PLAN COMMISSION REPORT

Proposal: Plan Review – Pay Kiosks, Trash/Equipment Enclosures

Address(es): 6900 S. 27th St. (2nd Aldermanic District)

1 PAY KIOSK ENLARGED PLAN
1/4"=1'-0"

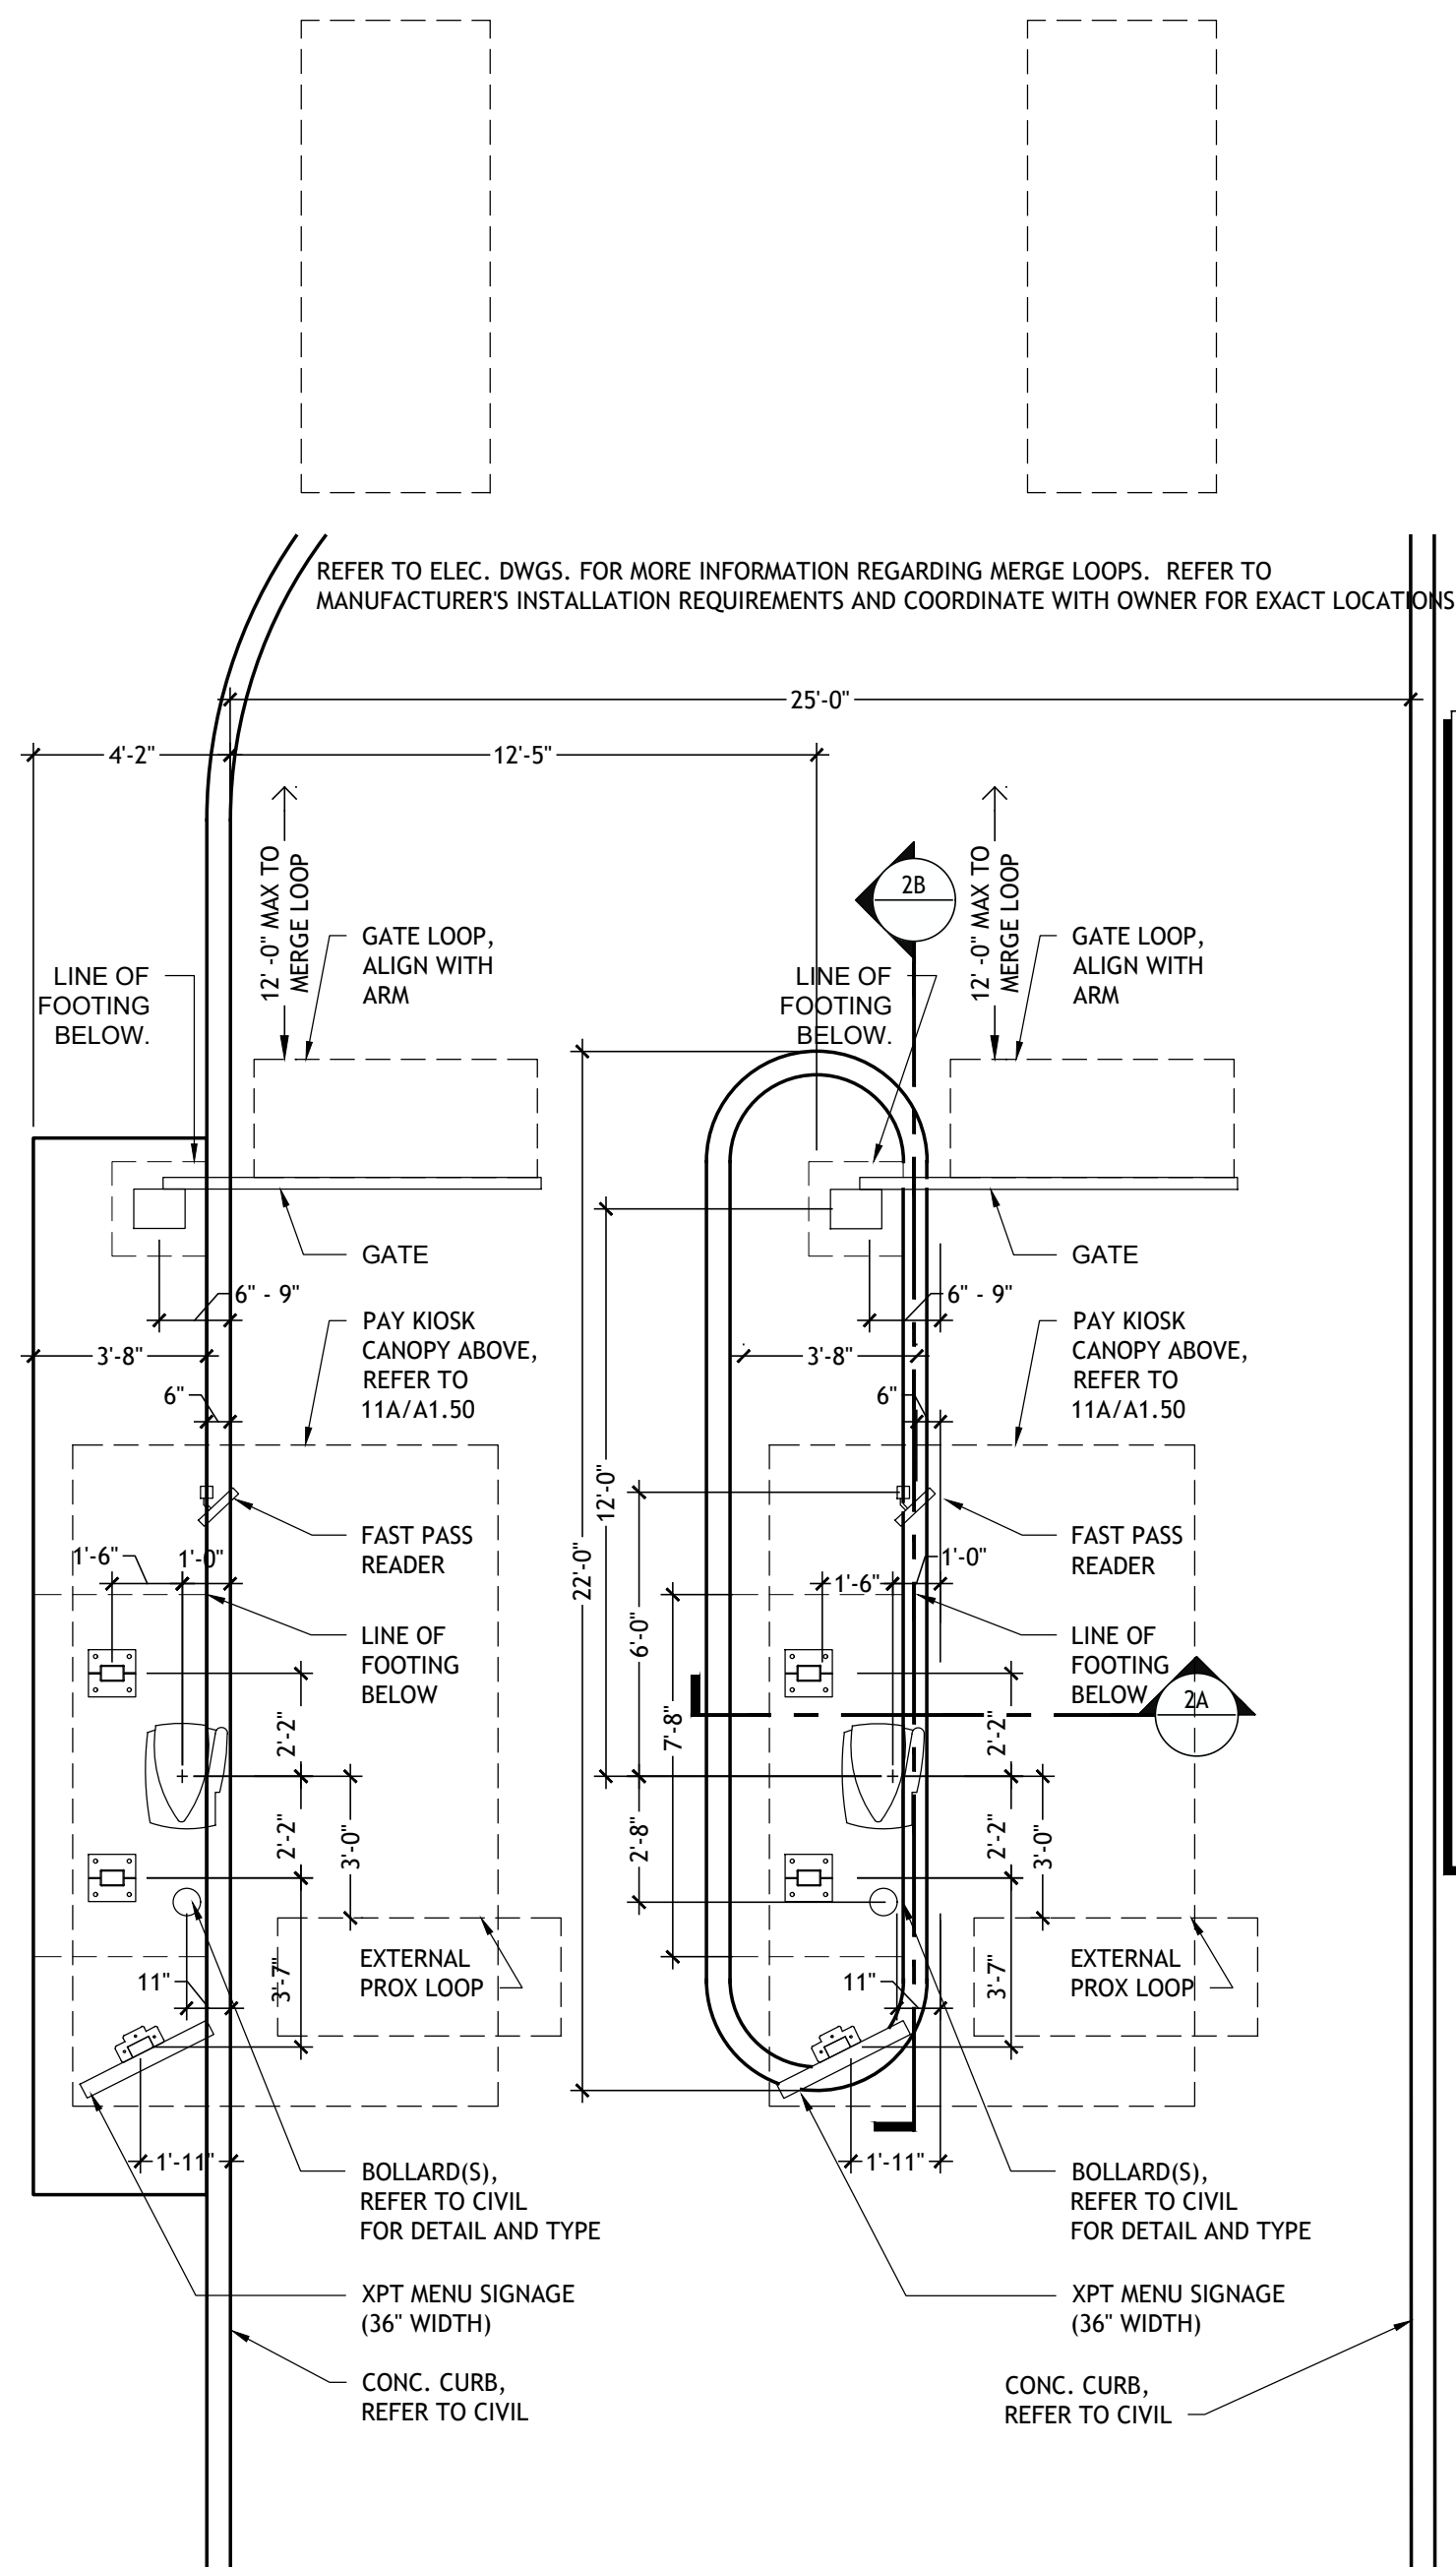
The proposed kiosks themselves are prefabricated blue metal arches over the pay station appurtenances. Plans indicate that they will be lit; however, lighting plans and details were not included in the submission. Canopy lights shall be limited to 25 footcandles, fully non-surface-mounted or recessed fixtures in conformance with Sec. 17.0509(b)(1)(j).
